Product Change Notification

Product Change Notification: E-18-007112

.050 CENTER LINE CARD EDGE CONNECTOR

BEFORE

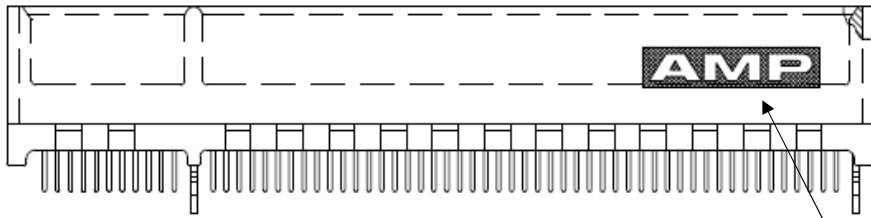
The drawing has been modified to correct following; Before: On customer drawing AMP logo is on right side. After: On customer drawing AMP logo will be moved to left side.

AFTER

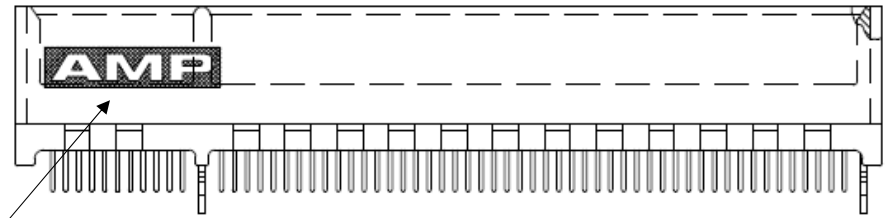
MOVE AMP LOGO FROM RIGHT SIDE
TO LEFT SIDE.
